This Addendum is due to some questions that arose during the bid process that require clarification. You must indicate in your bid that you have read and incorporated the addendum information in your bid.

- Gutters and down spouts are to be included in the building package.
- Duchesne County has a Geological report from a previous project that may be used as reference for foundation design.

West Elevation

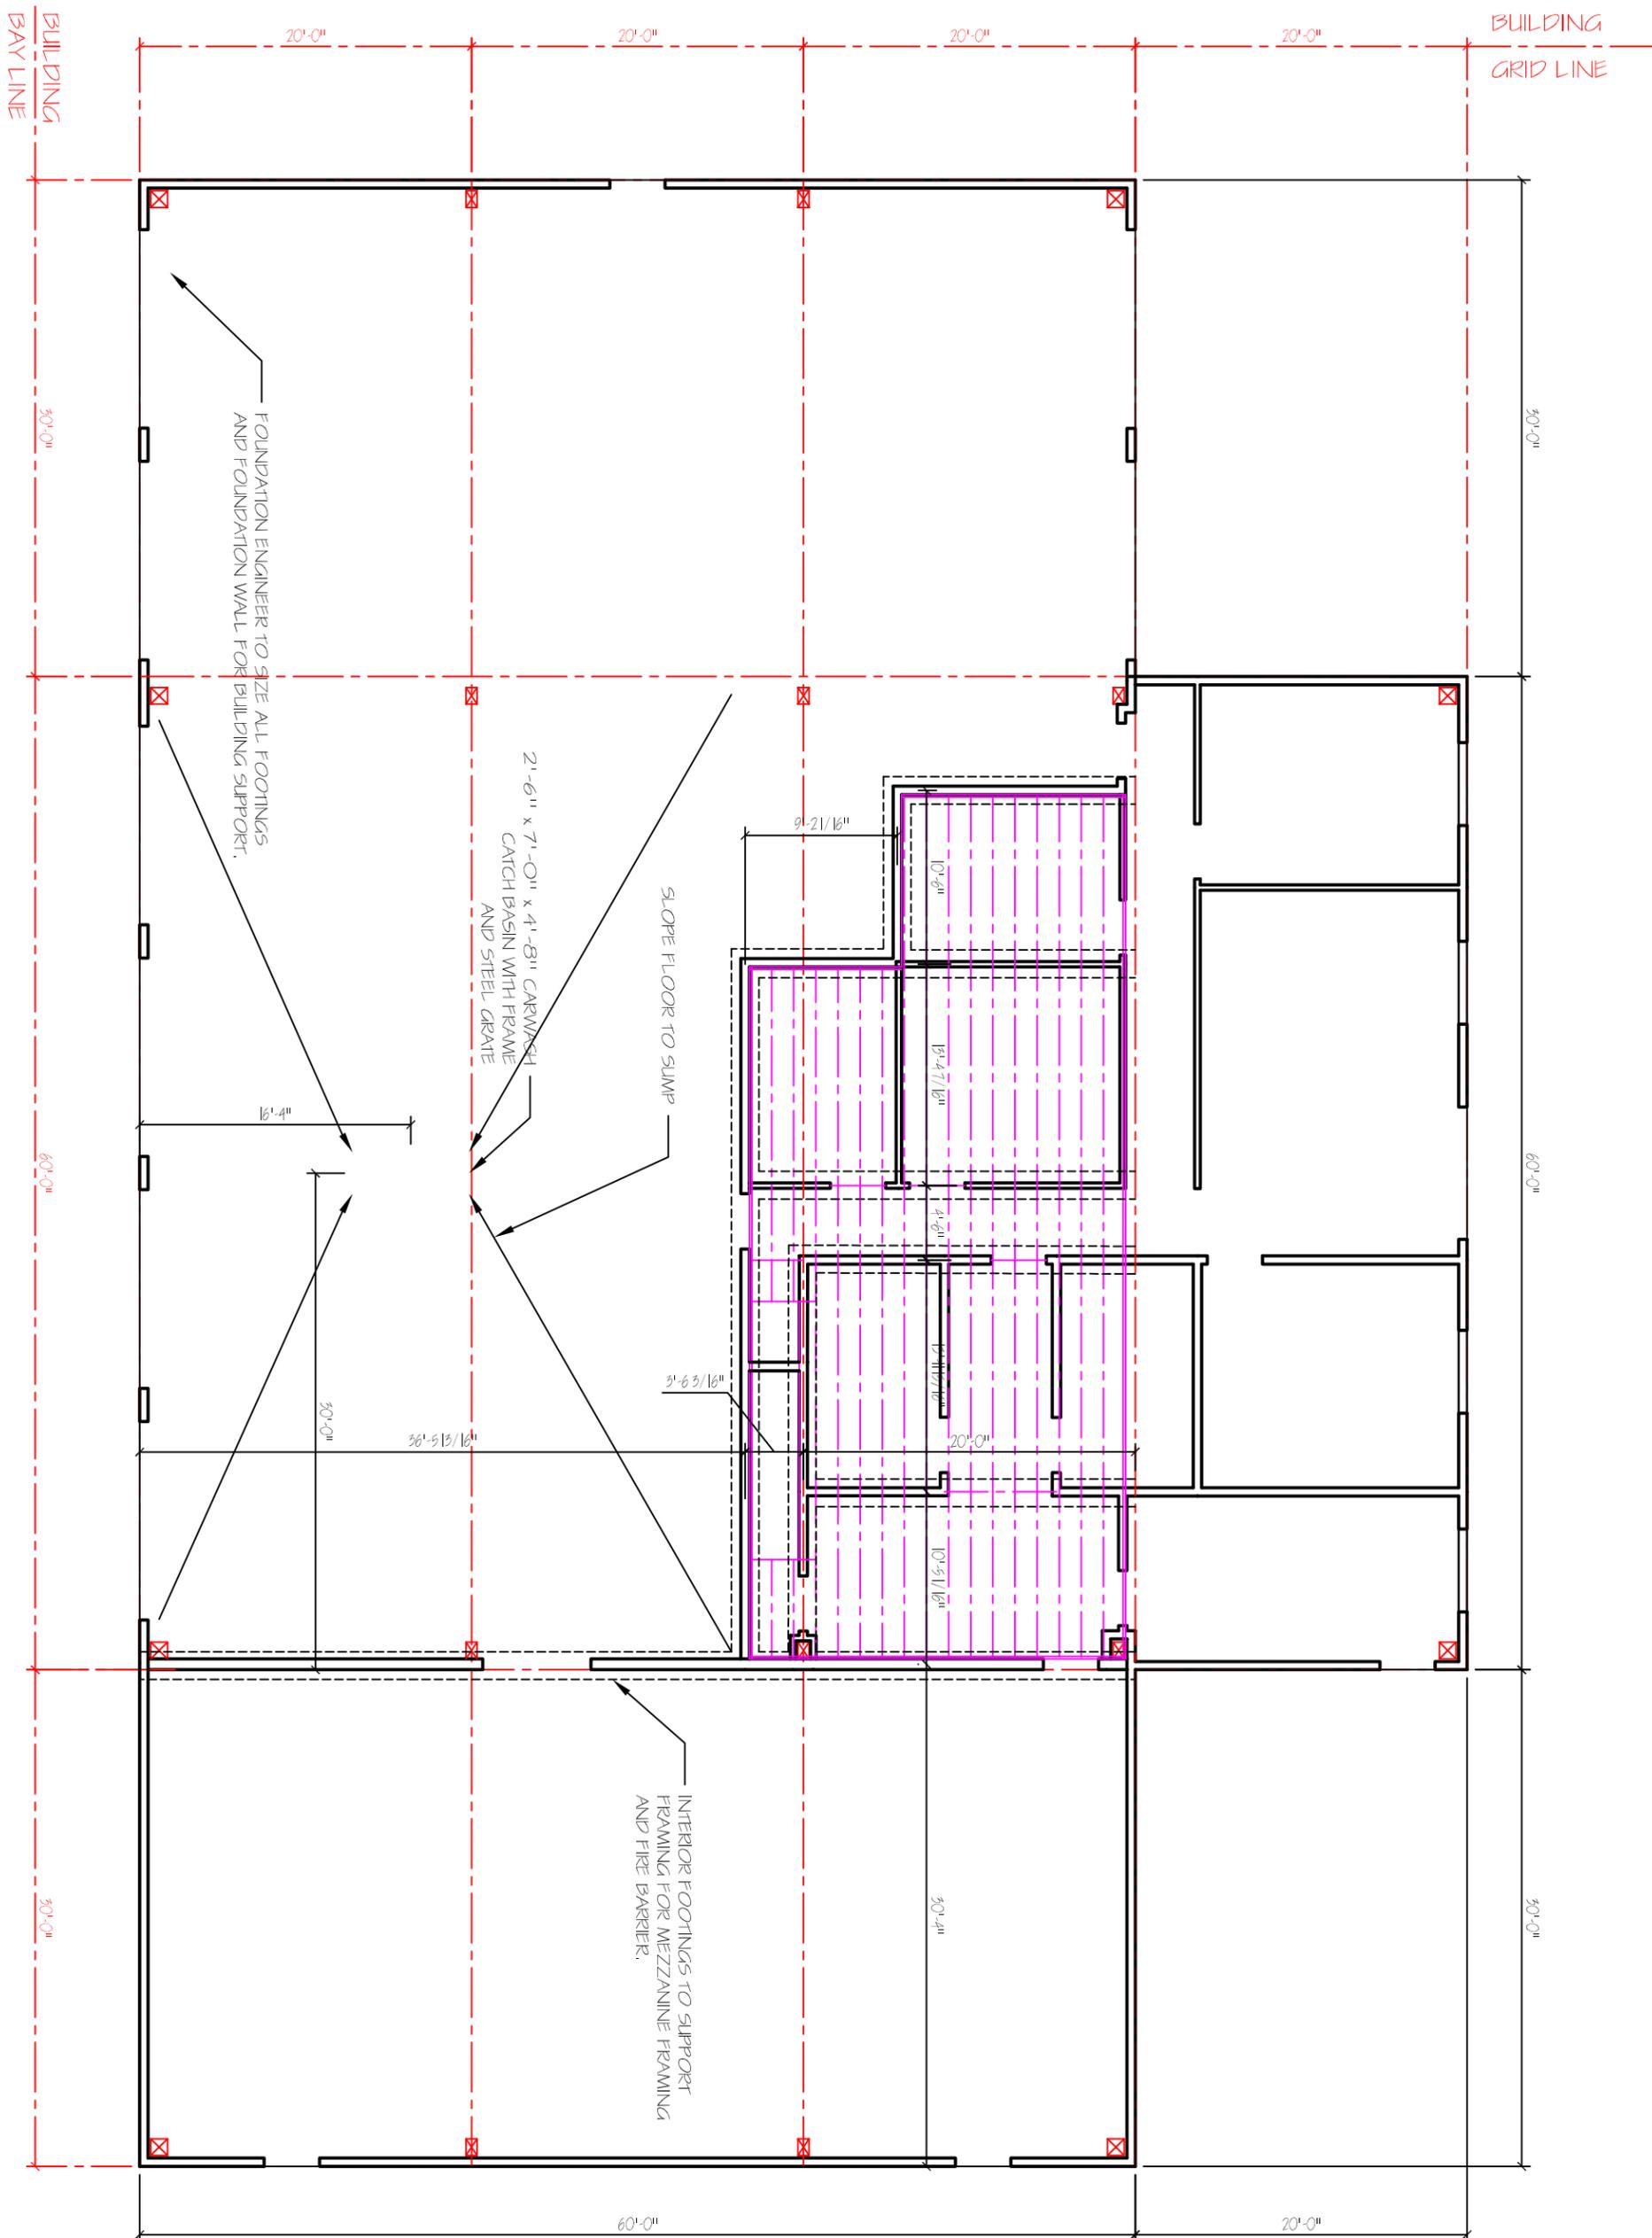
- In the Maintenance Building, the overhead doors in the west wall are to be the High / Vertical lift option. All doors are to be provided with door openers. Doors in the North wall are to have remote control openers.

PRELIMINARY MEZZANINE FLOOR FRAMING

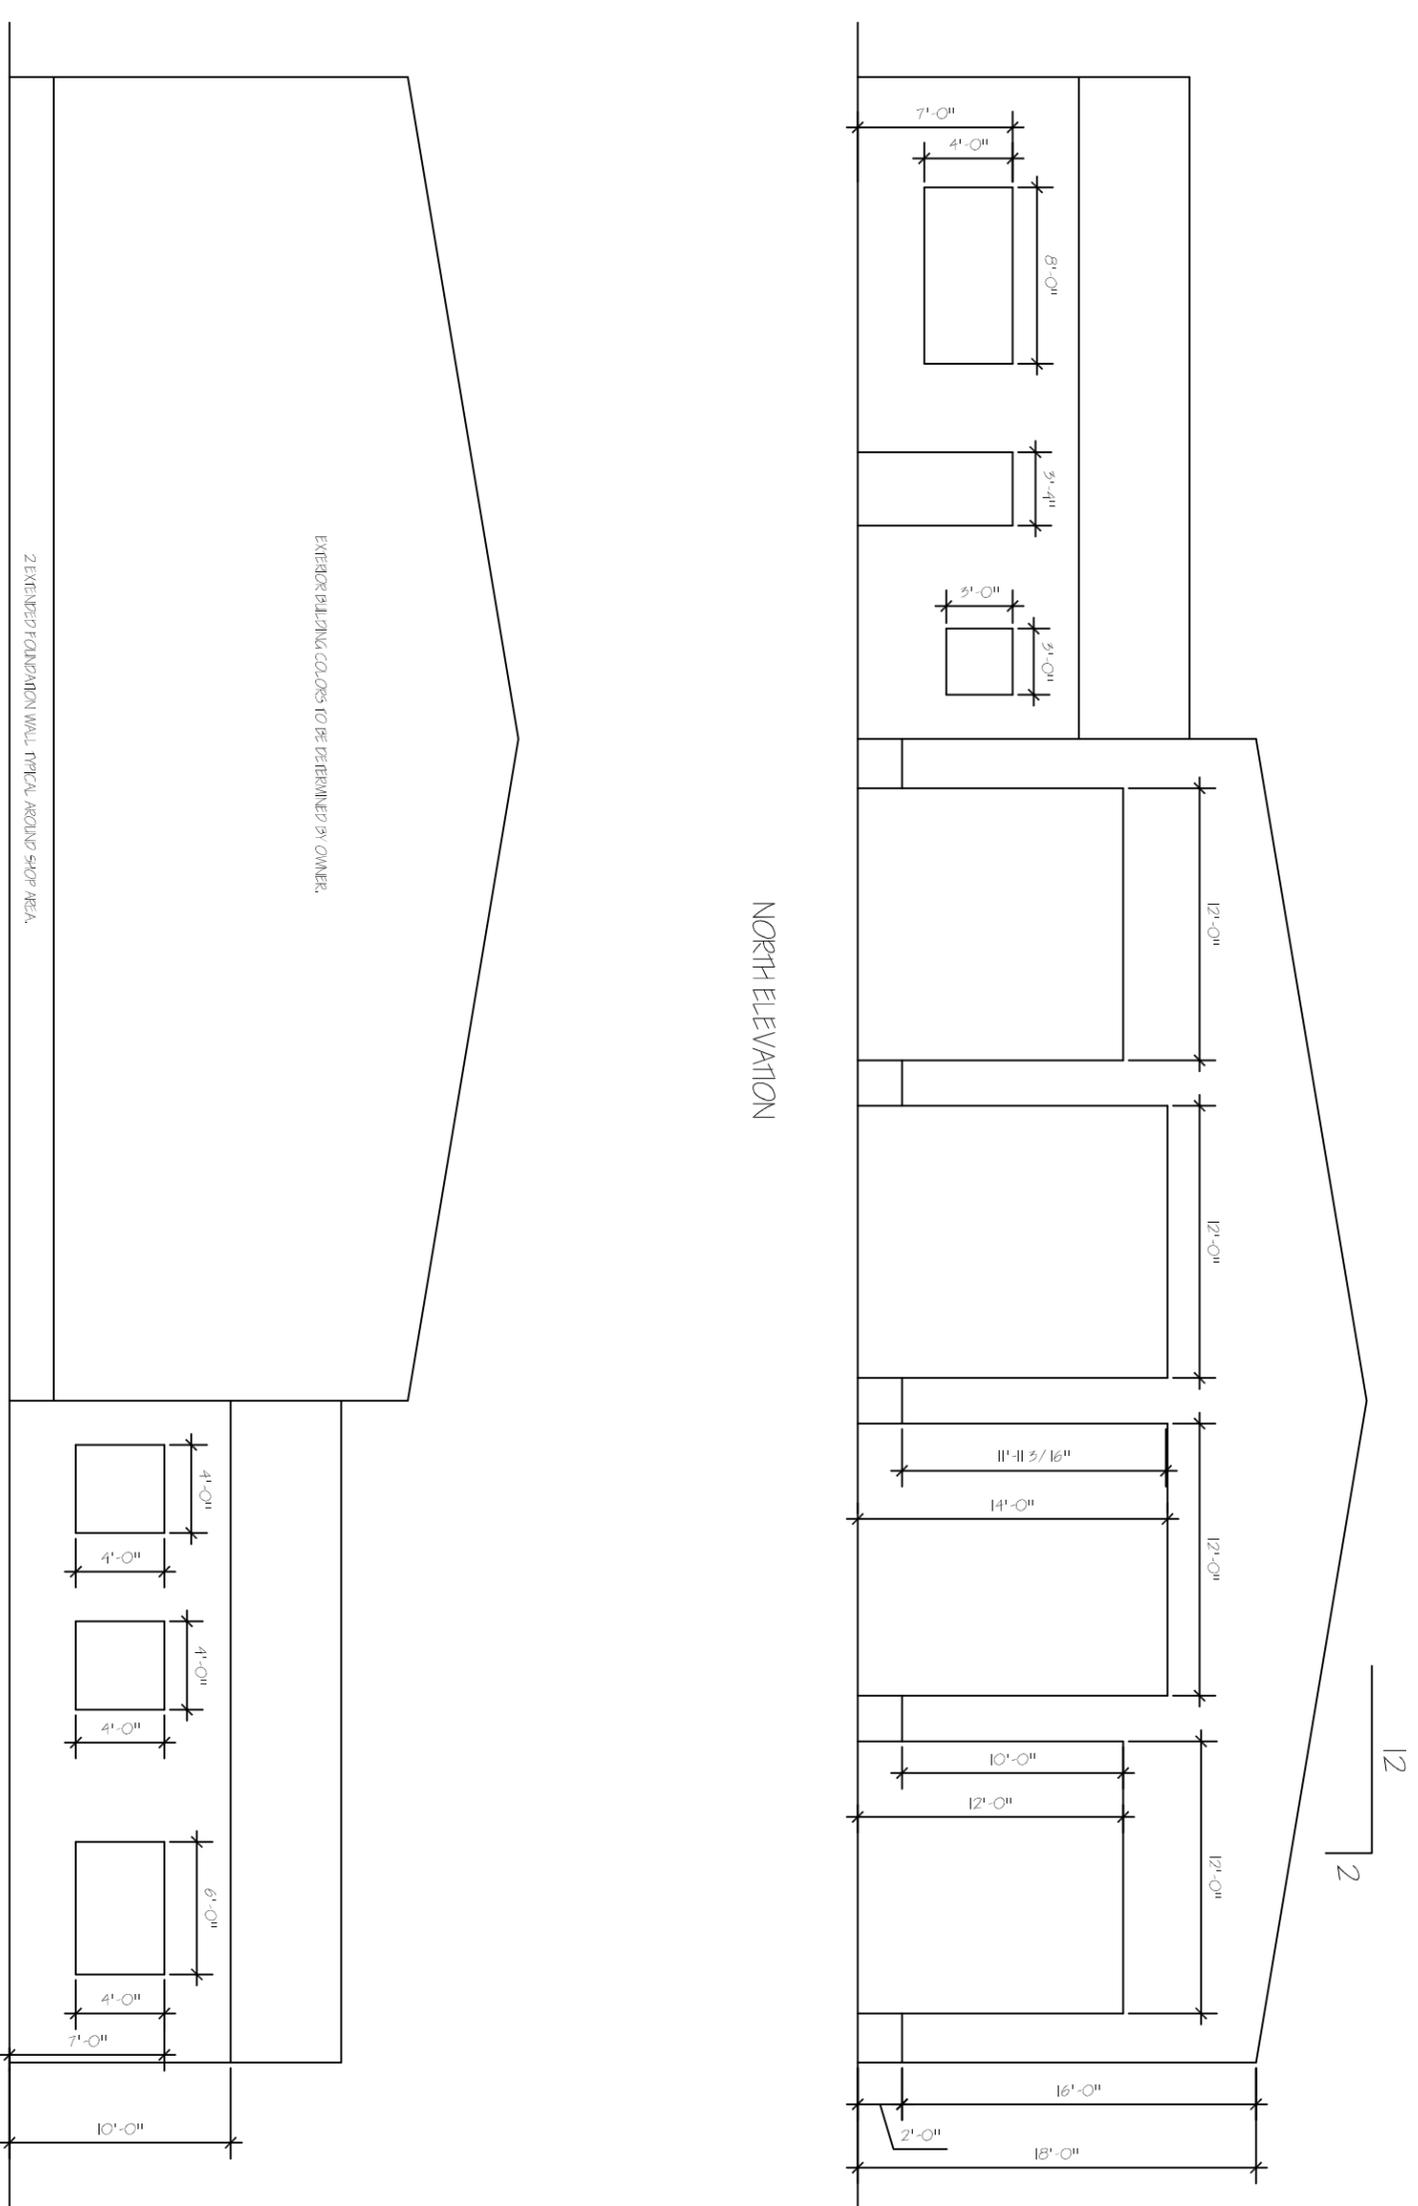
- The preliminary foundation plan provided shows estimated interior footings that will be required for mezzanine support. Final size and location will be determined by the foundation engineer. The bid package plans have been updated to show a preliminary mezzanine floor framing layout.
